2CAN090601

Subject: Response to Request for Additional Information on ANO-2 Steam Generator  
Tube Inservice Inspection Report  
Arkansas Nuclear One – Unit 2  
Docket No. 50-368  
License No. NPF-6

**Response to NRC Request for Additional Information on  
Steam Generator Tubing Inservice Inspection Report**

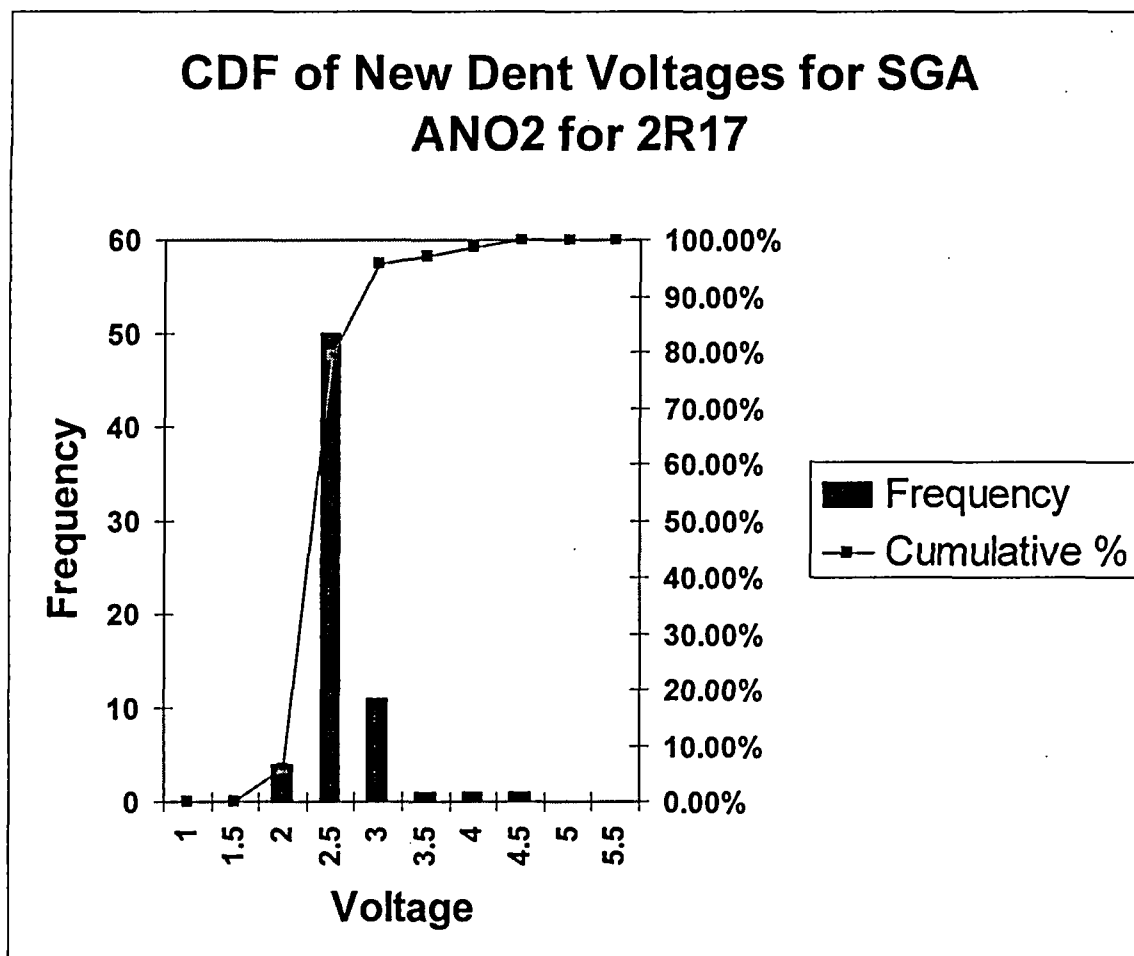
**NRC RAI 1** *Discuss the scope and results of any dent and ding exams performed during the Cycle 17 steam generator (SG) tube inservice inspections. Please discuss whether any rotating probe exams were done and include the number of dents/dings in each SG. In addition, discuss whether there were any new dents/dings identified (if so, causal mechanism), whether there were changes in the dent/ding signals (if so, causal mechanism), whether any "anomalous" dent signals were identified, and the inspection criteria (e.g., greater than or equal to 2-volts).*

Dents/dings are identified with the bobbin campaign. The scope from 2R17 was 54% of the tube population. A review was performed to compare the dents/dings from 2R15 (spring 2002) to 2R17 (spring 2005). 2R15 was the first inservice inspection (ISI) after one cycle of operation and included 100% of the tubing. Both generator results were consistent with steam generator A (SGA) having the largest population of dents. Therefore, for this report, SGA data is being reported. A cumulative distribution factor (CDF) of the change in voltage for dents identified in both outages was performed. The mean change was approximately 0.6 volts which is considered an insignificant change based on the technique. This is presented in the graph below:

A review was performed of newly identified dents in 2R17. These were determined to be a function of the threshold limit of 2.0 volts as the vast majority of the newly reported dents were at this value. From the graph below, the majority of the dents remain at or near the detection threshold. Based on this data, the relative condition of the dents in the ANO-2 steam generators is not changing.
